SITE DEVELOPMENT PLANS  
FOR

BANK OF AMERICA

SECTION 15, TOWNSHIP 27, RANGE 24  
BLOOMINGTON, HENNEPIN COUNTY, MN

UNDERGROUND STORMWATER MANAGEMENT NOTES

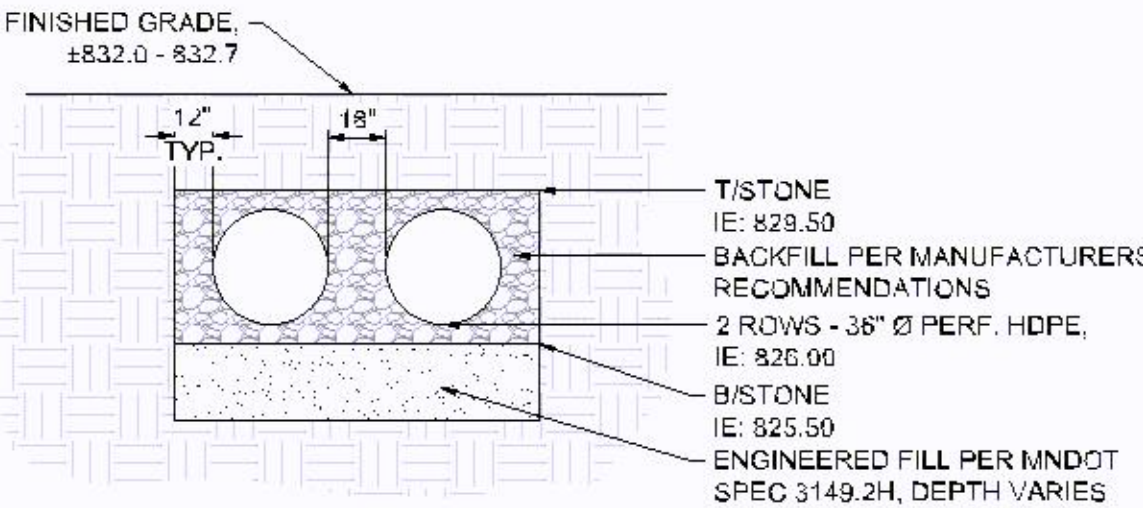
Engineer to provide Bloomington Engineering with copy of approved test results.

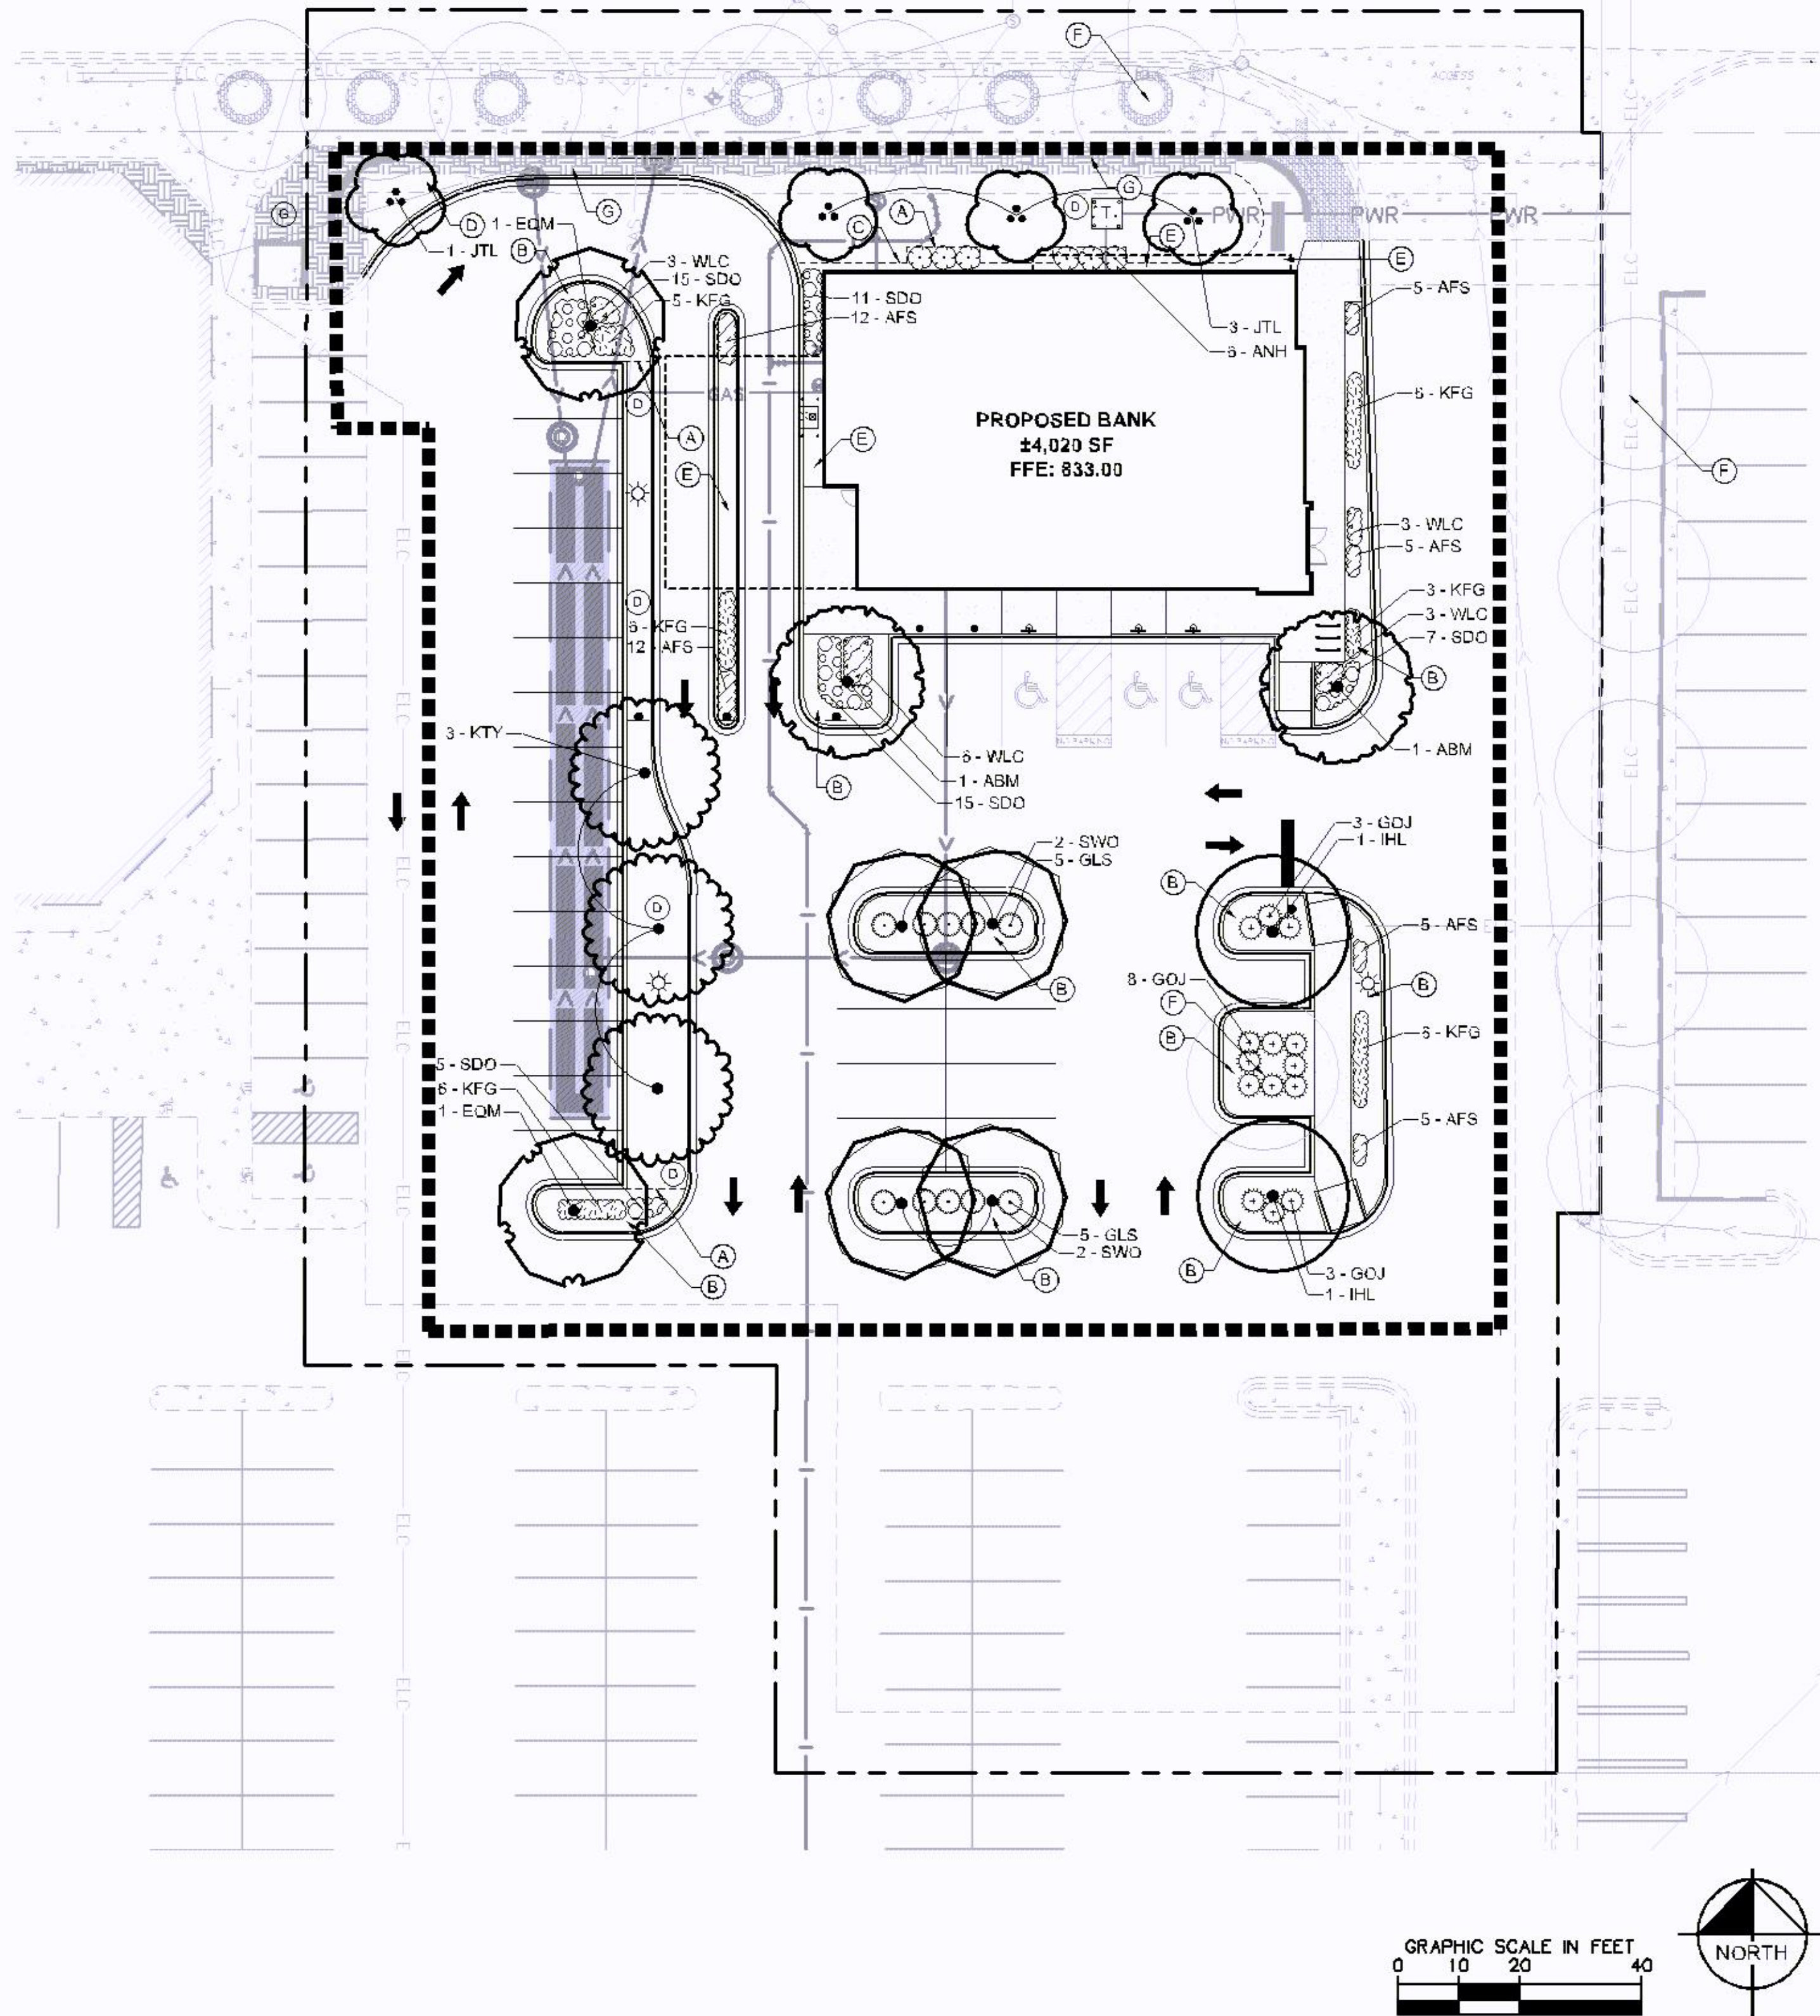
City records indicate this may be a 60 year old 6" Asbestos Cement Pipe Sewer service. There were some indications of issues/repairs in the past but not much detail is known. Project Engineer and Contractor should verify the condition of the pipe via CCTV for the owner. It may be necessary to rehab/line or replace the service.

Need a new valve to perform testing of the new water main and straighten out water service.

Use SDR26 or Sch 40

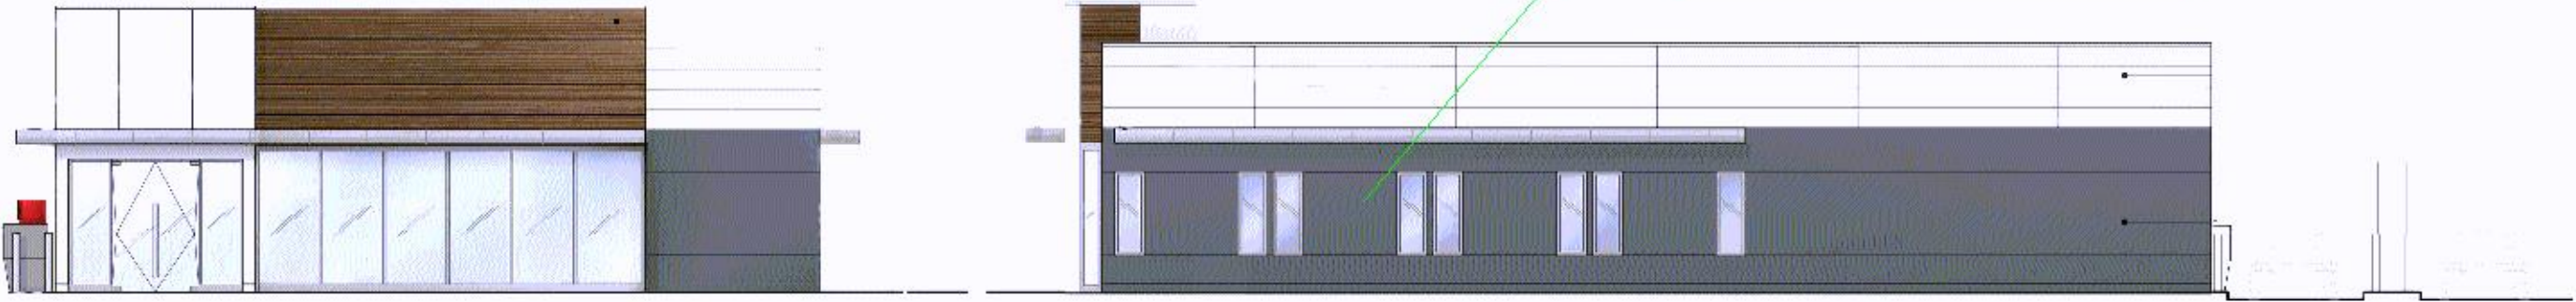
Document species of existing trees to verify they are not on the City's prohibited list (Sec. 18.03).

B North Elevations

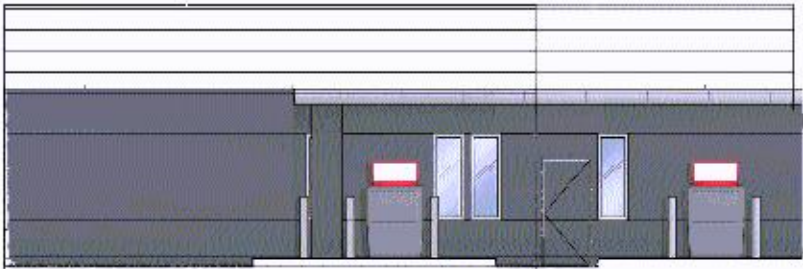
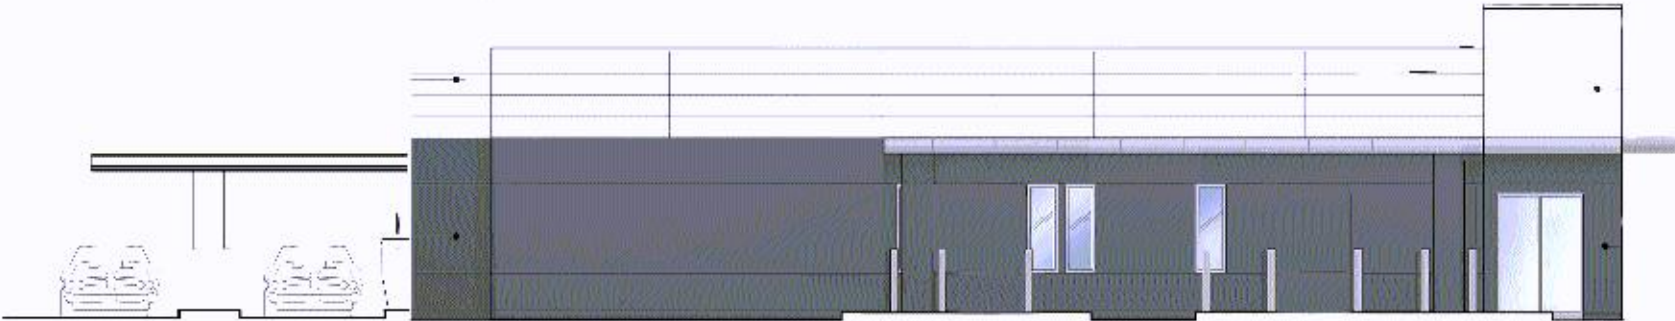
Section 21.301.03(a)(3) of the City Code requires architectural unity in terms of style, color and exterior materials among non-residential buildings constructed on one site. The other structures in the planned development are constructed of brick and are brown and dark red in color. The proposed building is not related in style, color or exterior material and requires modification.

50% of the northern elevation between two and ten feet in height must consist of transparent windows (Sec. 21.301.03(b)(1)). West 98th Street is the primary facade. More transparent windows are needed on the north building elevation.

Metal panels must comply with the City's Exterior Materials and Finish Policies and Procedures Guide. Panels will be reviewed for thickness, durability and finish warranty (30-year minimum required).
